# Work Order ID 107472

Item Name: Fwd Mid Height Crosstube 206L/L1/L3/L4, Blue

<b>DART AEROSPACE LTD</b> HAWKESBURY, ONTARIO, CANADA	
DRAWING NO. D206-667-147	REV. A SHEET 1 OF 4
TITLE CROSSTUBE ASSY (206L MID FWD)	SCALE NTS
COPYRIGHT © 2010 BY DART AEROSPACE LTD THIS DOCUMENT IS PRIVATE AND CONFIDENTIAL AND IS SUPPLIED ON THE EXPRESS CONDITION THAT IT IS NOT TO BE USED FOR ANY PURPOSES OR COMMUNICATED TO ANY OTHER PERSON WITHOUT WRITTEN PERMISSION FROM DART AEROSPACE LTD.

DRAWING NO. D206-667-147	TITLE CROSSTUBE ASS'Y (206L MID FWD)	REV. A	<b>DART AEROSPACE LTD ENGINEERING ORDER</b>		D.E.O. NO. D206-667-147-A-1	SHEET NO. SHEET 1 OF 1	SCALE NTS
DRAWN 92	CHECKED ADS	MFG. APPR. [Signature]	APPROVED [Signature]		DE APPR. [Signature]		
DATE 11.07.15	DATE 11.07.20	DATE 11.07.21	DATE 11/07/21		DATE 11.07.21

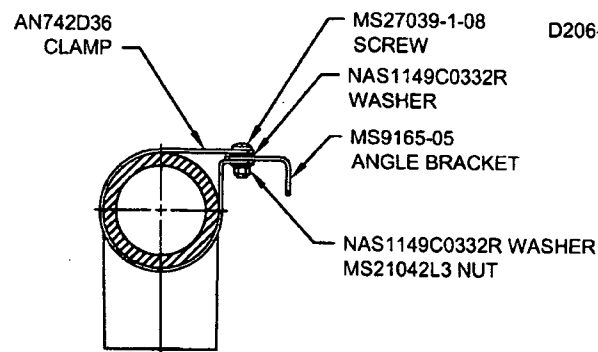
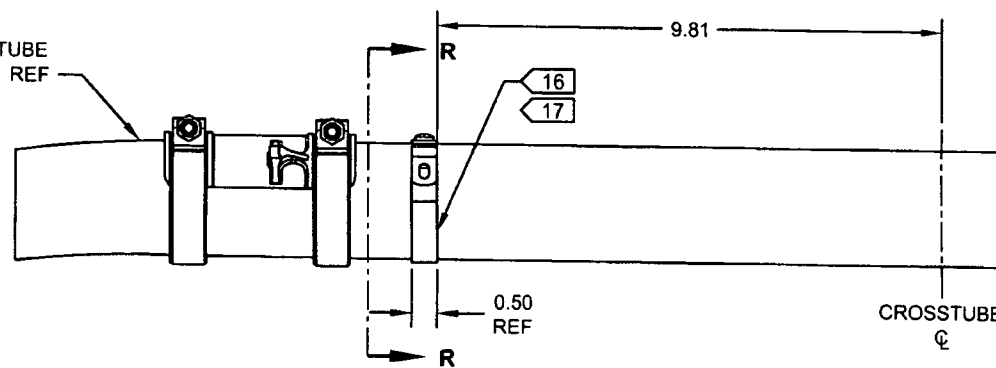
ADD ELECTRICAL GROUNDING STRAP

- 16) MASK AREA UNDER CLAMP PRIOR TO PAINTING
- 17) SEAL EDGES WHERE AN742D36 CLAMP MEETS WITH THE CROSSTUBE USING SIKAFLEX-241/-291 OR MIL-S-8802 CLASS B2 OR PROSEAL 890 SEALANT
- 18) PERFORM RESISTANCE CHECK TO ENSURE MAX RESISTANCE IS 10 MILLIOHMS
